## Meeting Summary

### Technical Team #13

March 14, 2018 | CDOT Offices – Golden

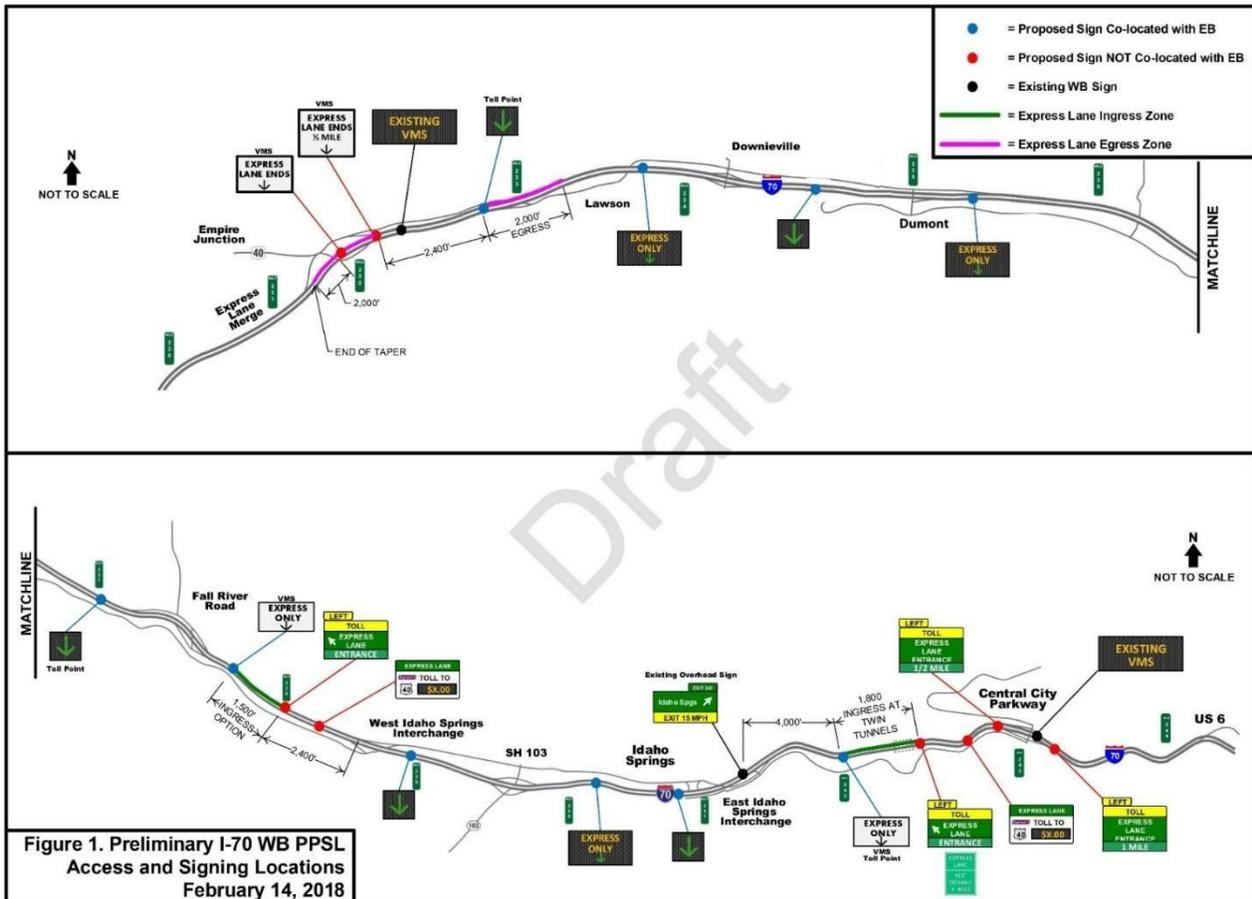
**Jo Ann Sorensen asked:** What type of median barrier will be implemented? Will it address glare, drainage, wildlife, etc?

**CDOT:** Glare shouldn't be an issue because of off-set elevations for EB and WB. Currently, considering a Type 10 barrier (i.e. Berthoud Pass).

**TT agreement:** The barrier used will need to consider functionality, drainage, aesthetics, wildlife.

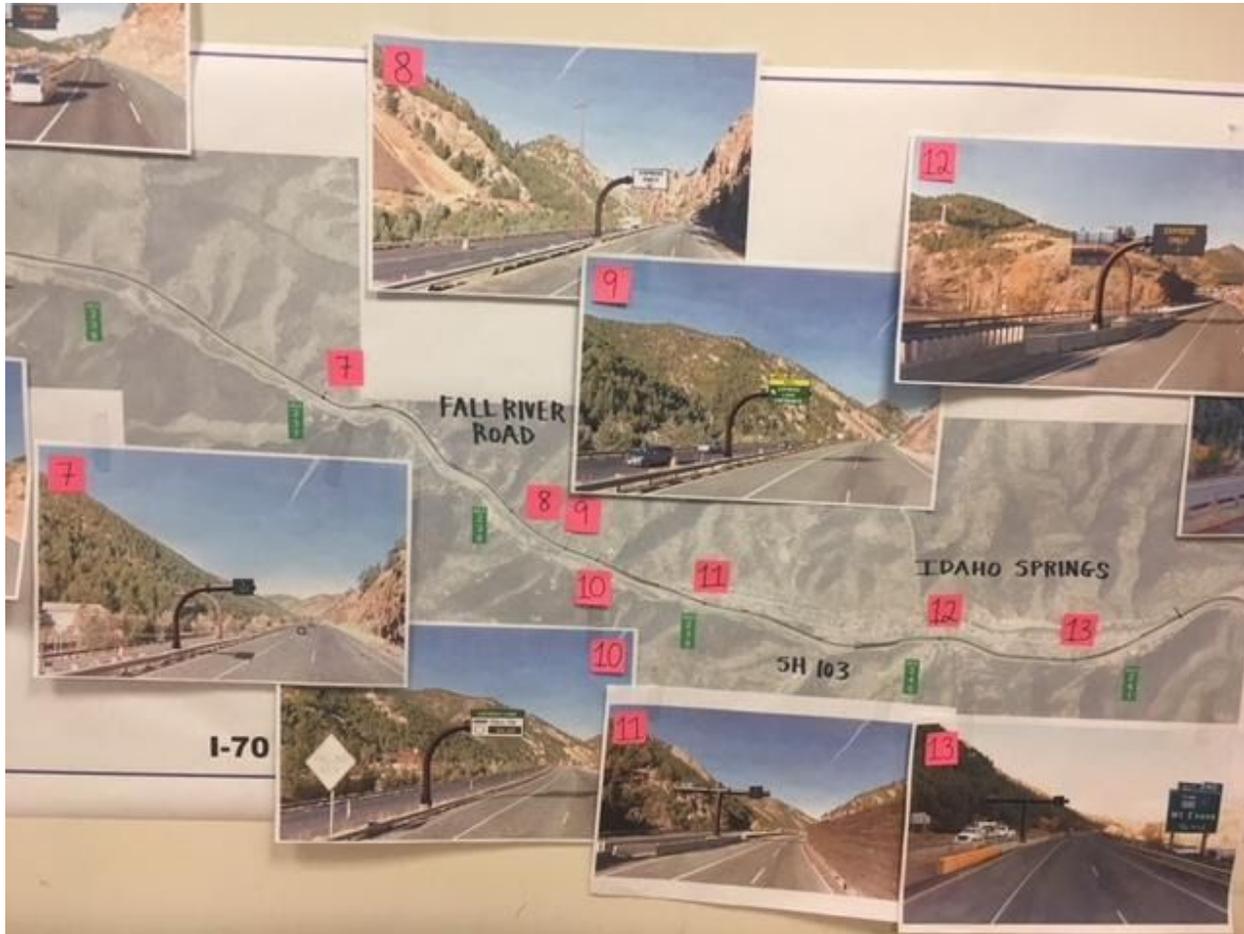
- Although Sign #16 impacts the viewshed, it is the correct location for safety reasons.
- Sign #15: consider moving it back away from the tunnel portal.

**TT Agreement:** When possible, signs should be on J-poles, more natural feel, organic. Every time there is a T-post, there is already another sign. These should be replaced with off-set J-poles when possible (i.e. Sign #13). Must be careful of setting J-poles too close together, looks bad (see Sign #12)

Sign #11: Dual J. Room to separate. Adjacent to sound wall.

Sign #9: Lonesome sign – might be co-located with EB sign.

Sign #8: Lonesome sign

Sign #7: Adjacent to existing – vertical separation. Suggestion to move #7 so there is less of a gap between #6 and #7. This will need to be examined because this correlates with moving a toll-point on EB operations. Will need to consider this in operations.

Sign #6: Long gap between #6 and #7. Consider options to close the gap. Need to review MUTCD re: sign placement.

Sign #5 will go to J-post

**Cassandra Patton suggestion:** Where there are “bump outs” around the signs, need to add more room in shy distance area to give drivers more space.

**ACTION:** THK will update the "T" post signs to be two mono tubes per the TT direction
